UNITED STATES
NUCLEAR REGULATORY COMMISSION
OFFICE OF INSPECTION AND ENFORCEMENT
WASHINGTON, D.C. 20555

IE Bulletin No. 80-20 Page 1 of 2

FAILURES OF WESTINGHOUSE TYPE W-2 SPRING RETURN TO NEUTRAL CONTROL SWITCHES

PROPOSED REWIRING OF INDICATING LIGHT CIRCUIT (TYPICAL) NEUTRAL SWITCH CONTACT INDICATING LIGHT (+) FIGURE 1

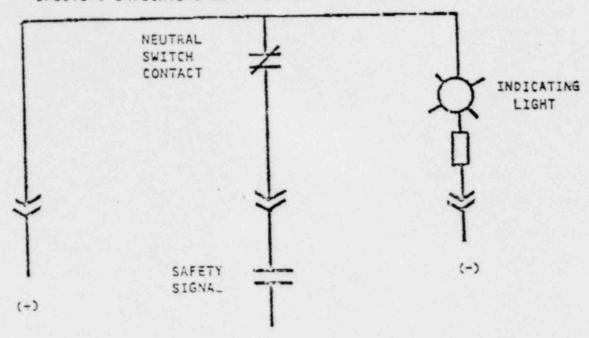
A review of this matter by Westinghouse led to the issuance of NSD Technical Bulletin No. NSD-TB-80-9 to the utility owners of all Westinghouse operating plants. The recommendations contained in the Westinghouse technical bulletin include: (i) testing the neutral position contacts of the subject W-2 switches for continuity, and (ii) rewiring of the indicating light circuit to permit the early detection of a neutral contact failure as shown in Figure 1.

Depending on how the indicating light circuit is wired, loss of continuity thru the neutral position contact of a W-2 switch could remain undetected until the equipment associated with the switch ere called upon to operate. Since such a failure would be equivalent associated in the switch, consideration should a rewiring the switches used in safety-related applications as shown in Figure 1. Such rewiring would provide an acceptable means for detecting contact failure, provided the indicating light is in the control room and readily visible by the operator. If the indicating light is not so located, consideration should be given to annunciating the neutral position contact failures at the control room to alert the operator of the inoperable status of a safety-related system. In addition, consideration should be given to adding redundant contacts to the W-2 switches or to replacing the W-2 switches with others having a more positive contact wiping action.

- 3. Licensees of operating plants and holders of construction permits shall describe the longer term corrective measures planned and the date by which such measures will be implemented by actual installation or by design change, as appropriate. As a minimum, the longer term corrective measures should include rewiring the indicating light as shown in Figure 1 provided the light is readily visible to the control room operator. If not, failures of the neutral position contacts should be annunicated in the control room.

REWIRING OF INDICAT NG LIGHT CIRCUIT OF N-2 SWITCHES

AS RECOMMENDED BY WESTINGHOUSE TECHNICAL BULLETIN NSD-TB-80-9
